CHAPTER 5

COMMENTS AND COORDINATION

CHAPTER 5 – COMMENTS AND COORDINATION

Figure 2-2
10-Southbound Lanes Site Plan
VIRGINIA AVENUE PEDESTRIAN FACILITY & I-5 SOUTHBOUND REALIGNMENT

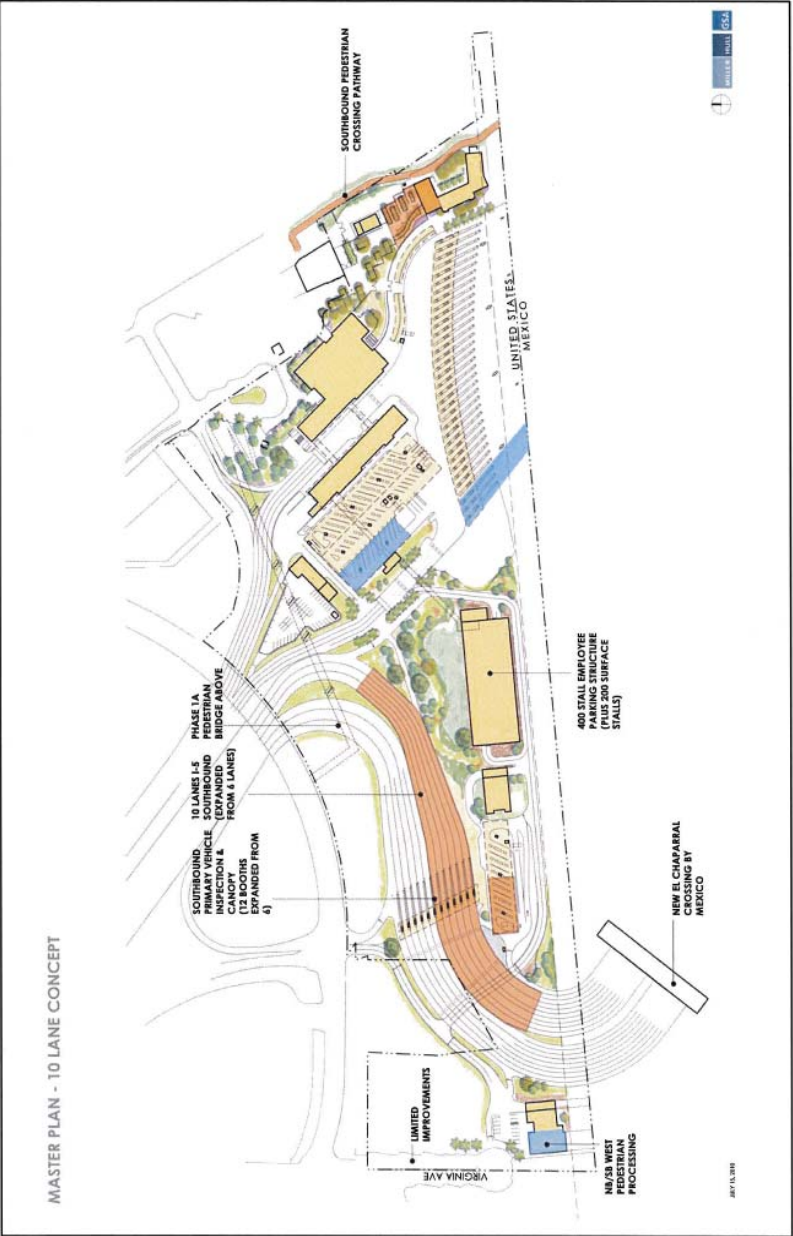
- The I-5 SB off ramp to CDLP be impacted. The right turn pocket should be lengthened to accommodate this.
- D10
- Figure 2-2: 10-Lane Alternative comments:

- Do not show the lanes being split immediately in half by delineation just to show the 6 lanes on the south side segment (shaded in orange). See Attached.

- D11
- Figure 2-2 is a 12-lane configuration.
- D12
- Figure 3-2; Existing Volumes comments:
 - Study Intersection #2; SB and I-5 Off-ramp counts at Via de San Ysidro are too low.

- D46 33) The demand volumes used on Table 10-2 do not all match previous figures.
- D47 34) Figure 2-2 shows the 10 lane configuration alternative. In this drawing, the 10 lanes do not reach even half way to CDLP Bridge. The queue calculations assume 10 lanes to the bridge (0.2 miles).

- D9 See response to comment D8.
- D10 See response to comment D5.
- D11 Figure 2-2 in the traffic report has been updated to reflect 10 lanes in the southbound roadway.

- D46 Figure 8-2 in the traffic report has been revised to show the correct near-term demand volumes.
- D47 The exhibits contained in the traffic study of the analyzed alternatives are preliminary concepts of the alternatives being considered. The queue analysis for the Ten-lane Alternative assumed the southbound roadway would include ten lanes between the Camino de la Plaza overcrossing and the border, using a distance of 0.2 mile. A reduction to this distance would result in negligible changes to the queuing analysis.
